**Town of Rotterdam
Planning Commission
December 17, 2024**

1. **GDPL Ville Rotterdam, LLC (Contract Vendee) - 900 & 880 Duanesburg Road.** Final Boundary Line Adjustment/Site Plan/Special Use Permit Public Hearing for a ±102,725 square foot BJ's Wholesale Club with associated 8 island fueling station at 900 Duanesburg Road and a ±2,500 square foot retail building with associated drive thru. Engineer: ABD Engineers & Surveyors.

WAIVER OF SITE PLAN REVIEW

PC2024-W52

1 FLOOR PLAN
 1/4" = 1'-0"
 GROSS AREA: 2,461 S.F.

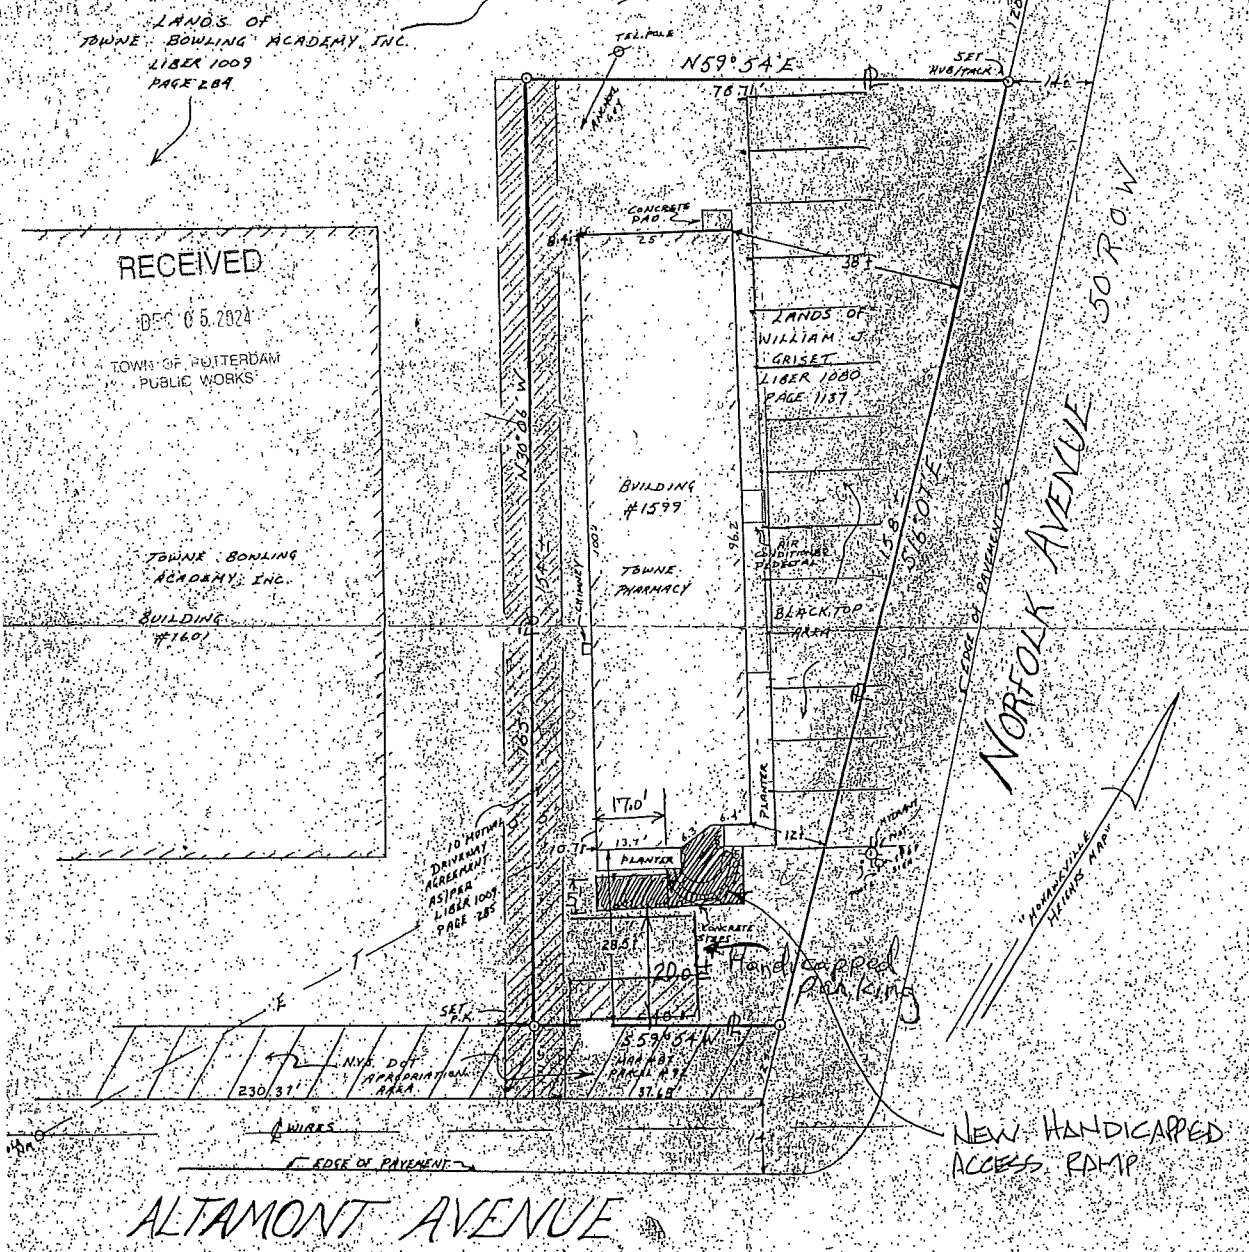
REQUEST: The applicant requests a Waiver of Site Plan review to utilize existing ±2,500 square foot building, former Sun Capsule (1599 Altamont Avenue), by placing six (6) pool tables for the extension of business at Towne Bowling (1601 Altamont Avenue) on a combined ±1.58-acre parcel.

1. Compliance with all NYS Building and Fire Codes.
2. Applicant shall obtain a Fire Inspection and/or Building Permit and be issued a Certificate of Occupancy from the Building Inspector/Code Enforcement Officer prior to operation.

3. Owner/applicant shall install Knox box for emergency personnel. Please contact Fire District #2 for specifics.
4. Applicant to comply fully with Town Sign Code and obtain a building permit for any signage.

5. Parcels, 1599 Altamont Avenue and 1601 Altamont Avenue shall be combined prior to the connection of the buildings.
6. All water shall be metered. Water meters shall remain on both buildings unless plumbing permit is obtained to connect plumbing systems.

7. Parking lot shall be patched, sealed, and striped no later than June 30, 2025.
8. A dumpster enclosure shall be installed at the rear of the building.

9. Handicap parking, signage, and access isle to the existing ramp shall be installed no later than June 30, 2025.
